MAVERIK, INC. STORE #250

5100 EAST & 2500 NORTH EDEN, UTAH

LANDSCAPE PLAN

**3** PAN CHANNEL LETTERS  
24" LETTER SET  
SCALE: 3/8" = 1'-0"

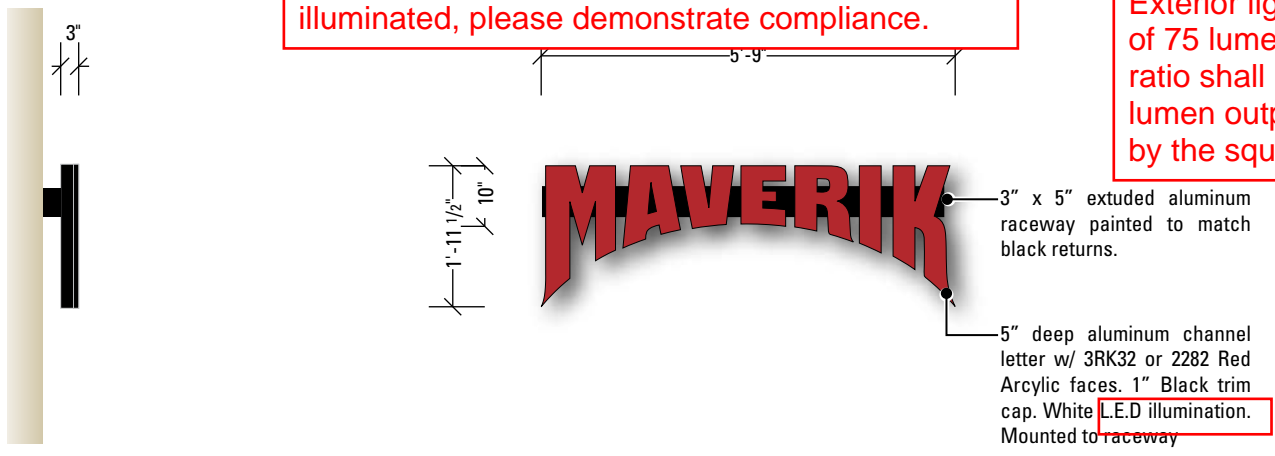
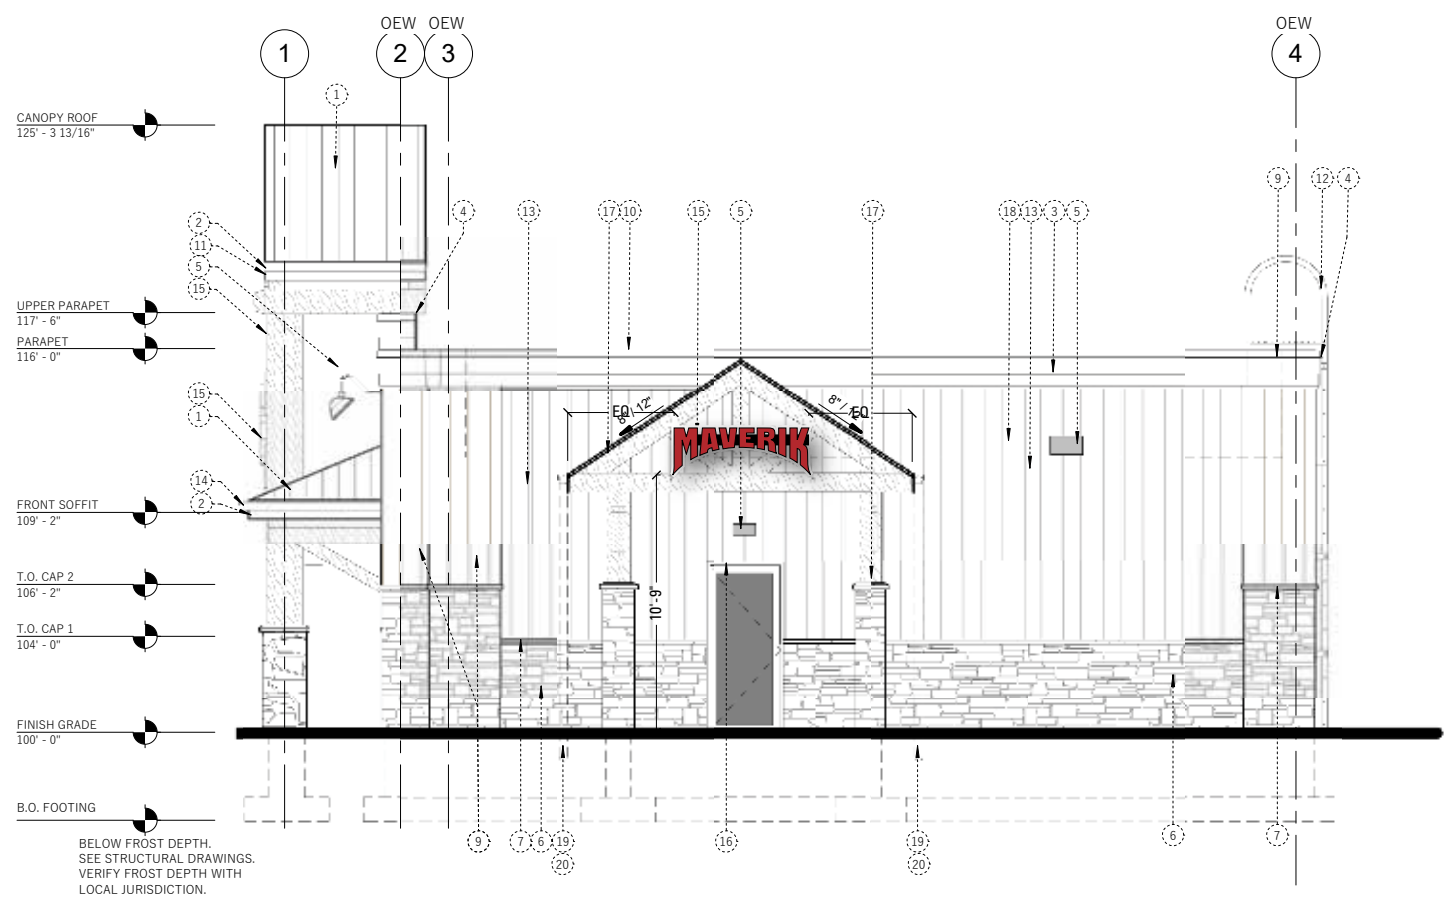
Unless otherwise specified, all exterior lighting of a sign shall be downward directed from the top of the sign, and oriented so as to illuminate only the sign area, as defined in section 101-1-7, excluding the supports. If proposing exterior illuminated, please demonstrate compliance.

This lighting is not permitted. If a downward directed light will be proposed instead, we will need to see illumination details.

Exterior lighting of a sign shall not exceed a ratio of 75 lumens per square foot of sign area. This ratio shall be calculated by combining the total lumen output of each artificial light source divided by the square footage of the sign area.

No direct artificial light, as defined in section 101-1-7, shall be projected from the sign area or beyond the sign area, including by means of diffusion or refraction through a translucent or transparent surface. However, direct artificial light, excluding diffused or refracted light, for a sign area that does not have a frame or separate background, as in the case of a logo or individual lettering mounted to a wall without a defined sign perimeter, may illuminate or reflect onto a background surface, such as a wall, beyond the exterior perimeter of the sign area, provided that: 1. It shall not exceed six inches beyond the sign area; 2. It shall be shielded so as not to project light onto any other surface.

**4** PAN CHANNEL LETTERS BONFIRE LETTERS Std. SIZE "A"  
SCALE: 3/4" = 1'-0"

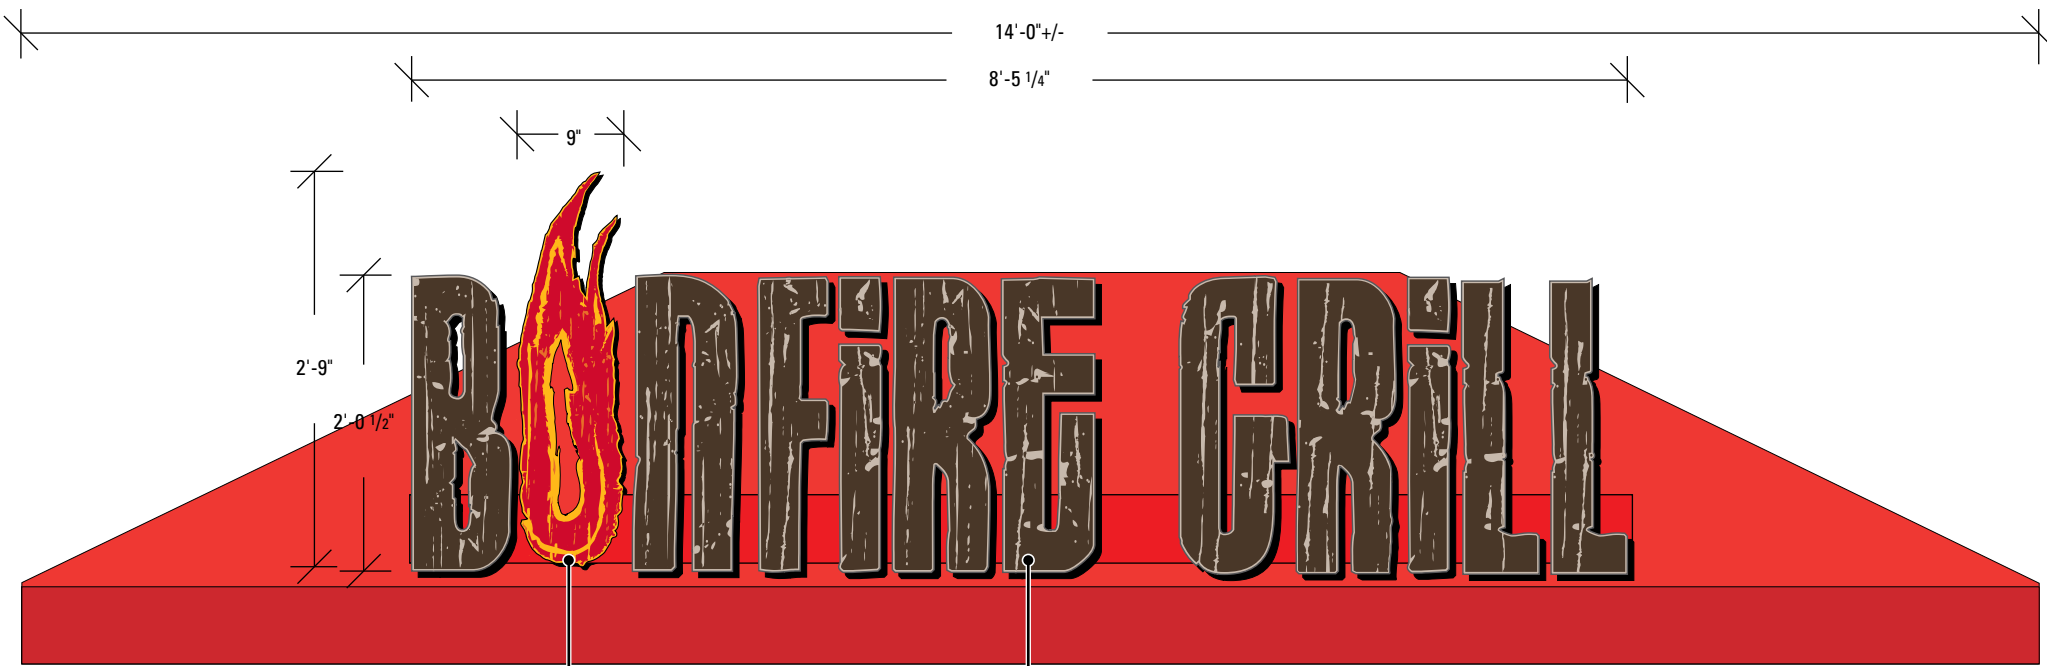
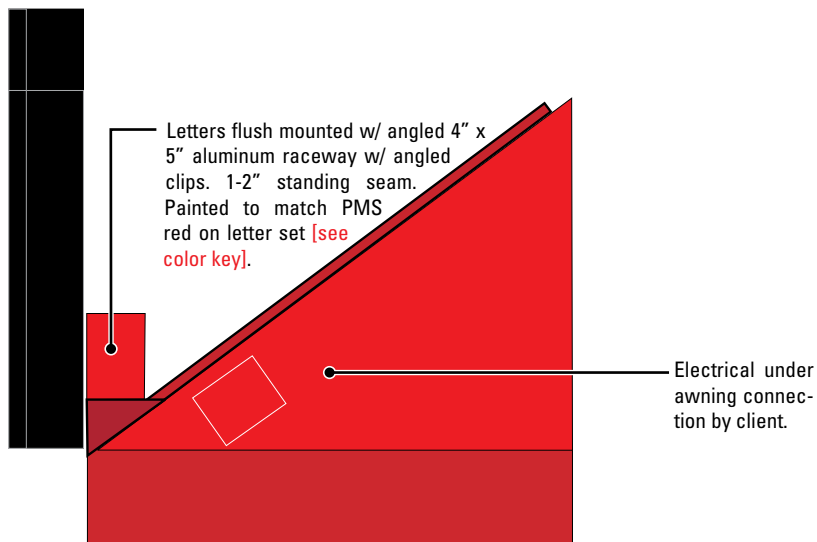
Please specify if this is indoor/outdoor lighting.

PROPOSED SITE PLAN

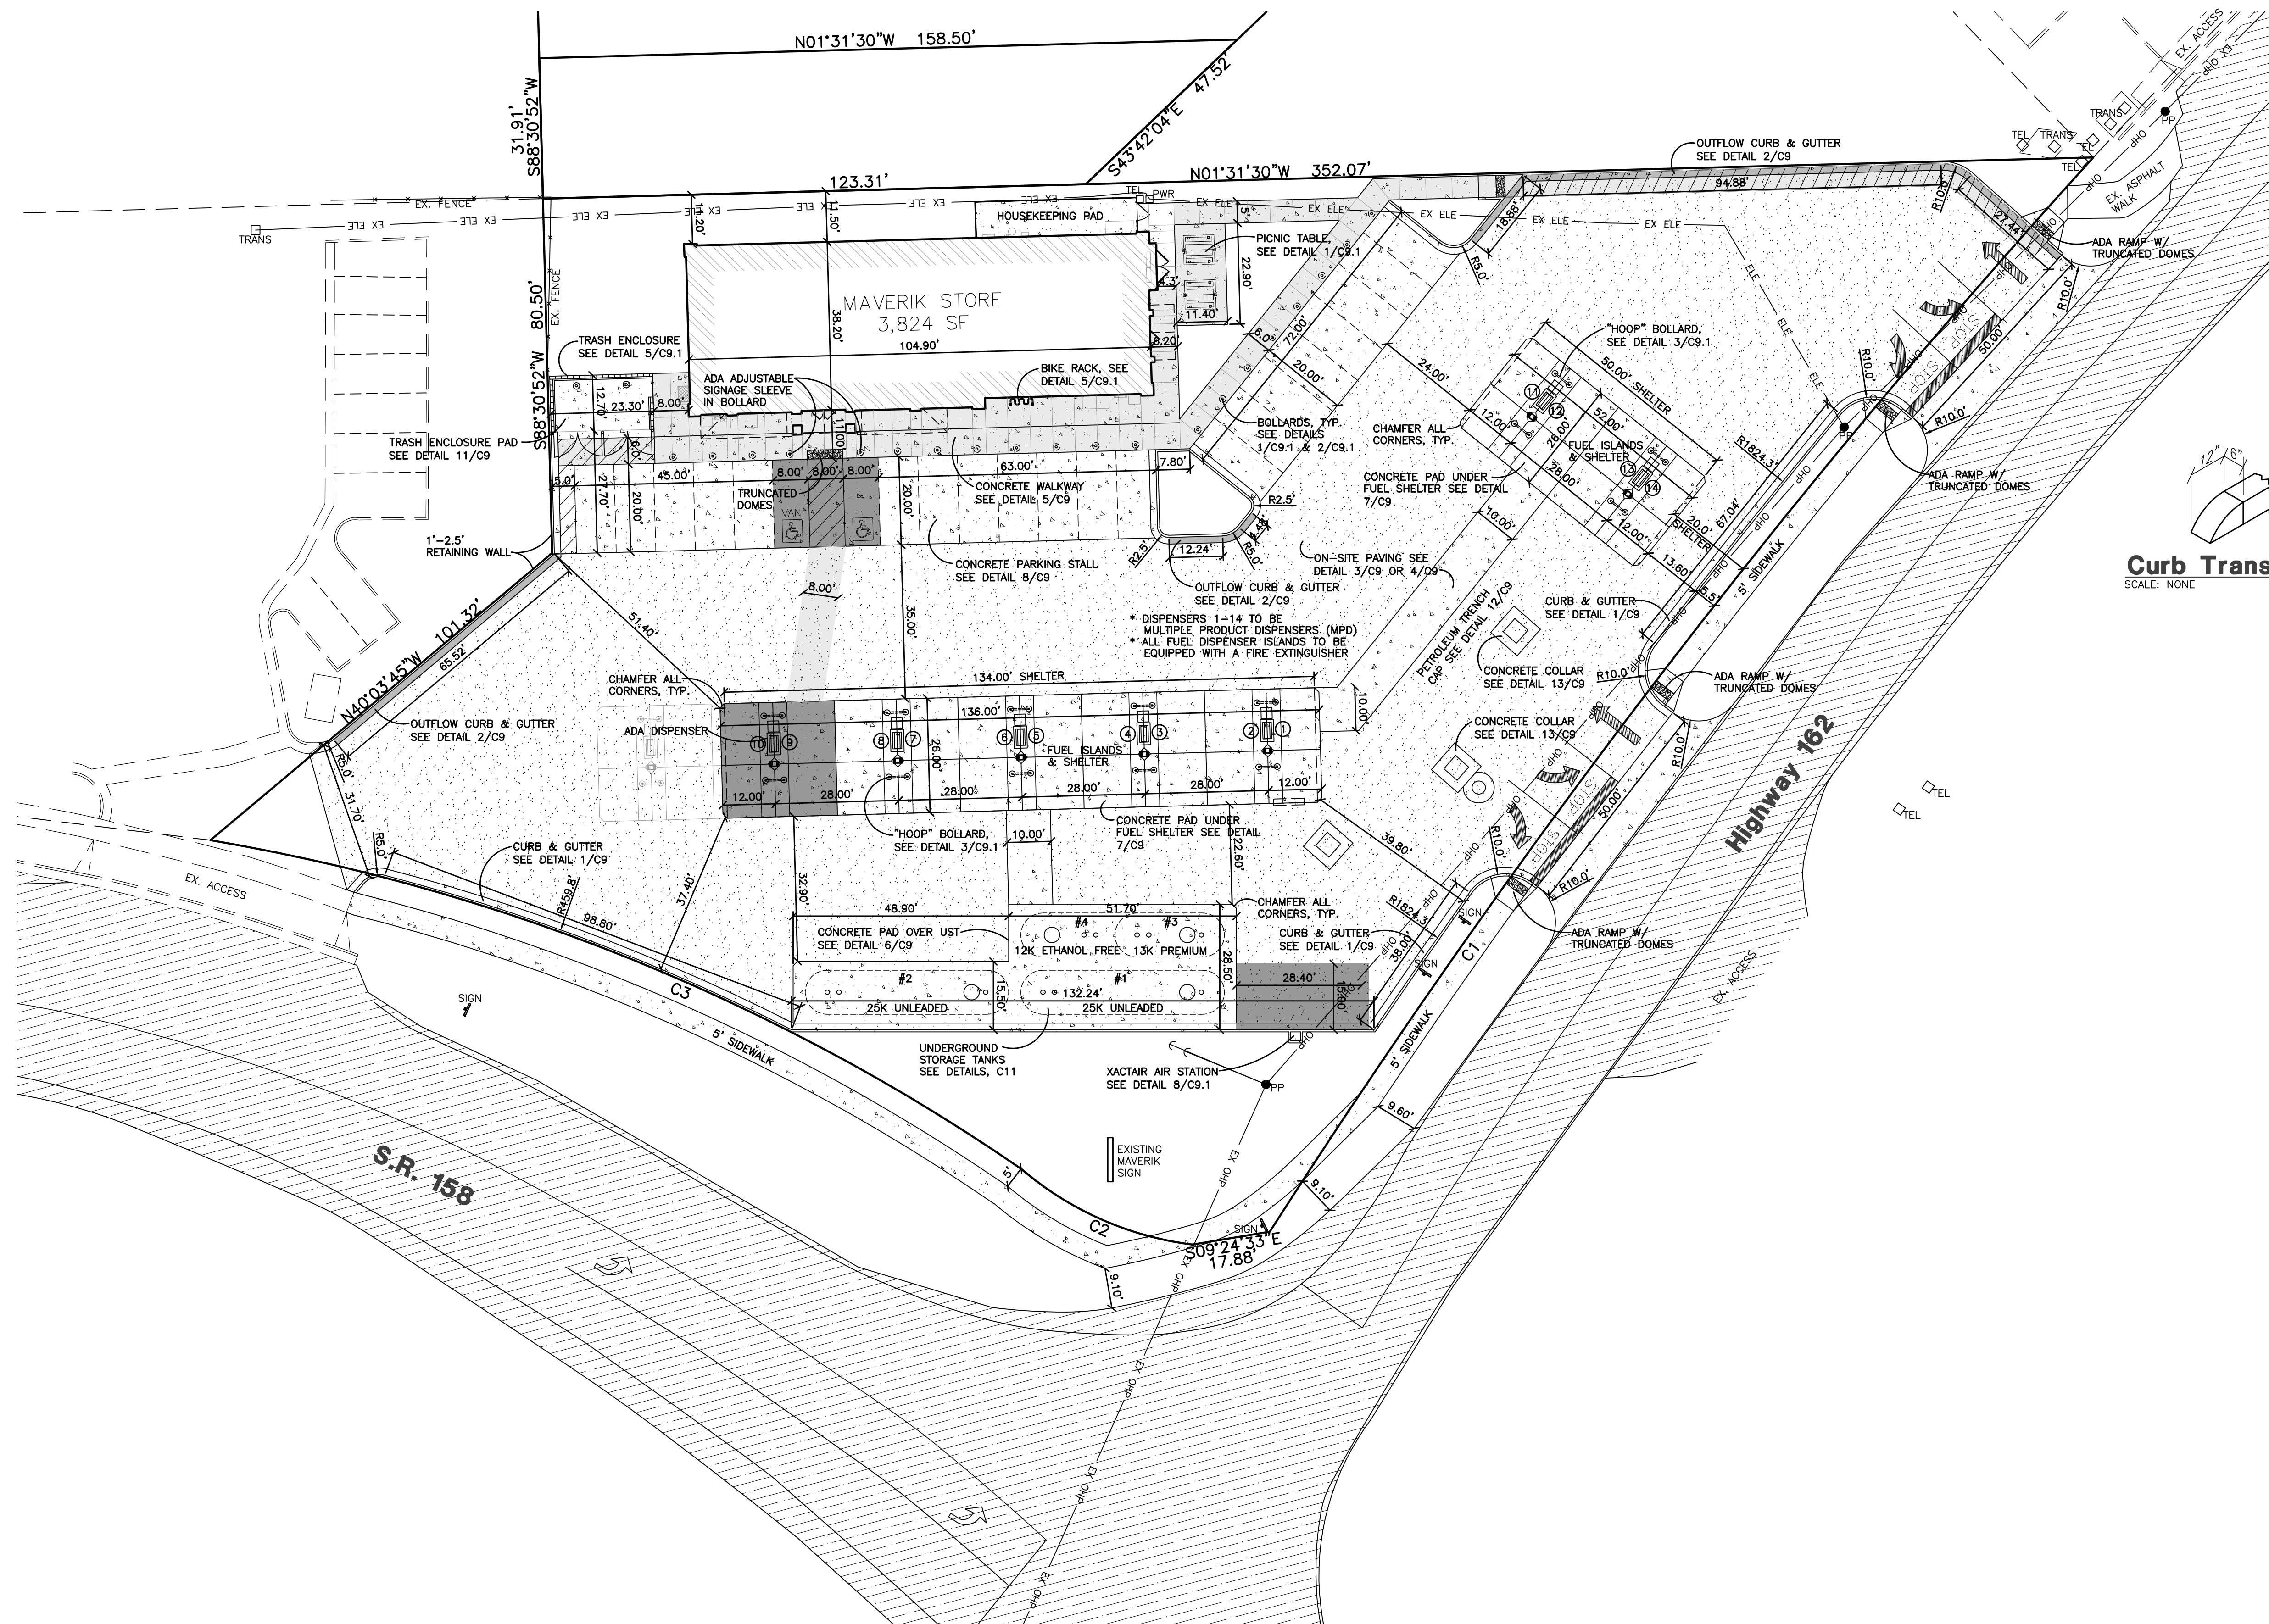
Any monument sign or ground sign shall be set back a minimum of ten feet from any property line. Signs fronting on state highways shall be set back ten feet from the right-of-way.

In all zones which require a front yard setback, no obstruction to view in excess of three feet in height shall be placed on any corner lot within the area designated as the clear view triangle, except those noted below. The clear view triangle is a triangular area formed by the front and side (street facing) property lines and a line connecting them at points 40 feet from their intersection.
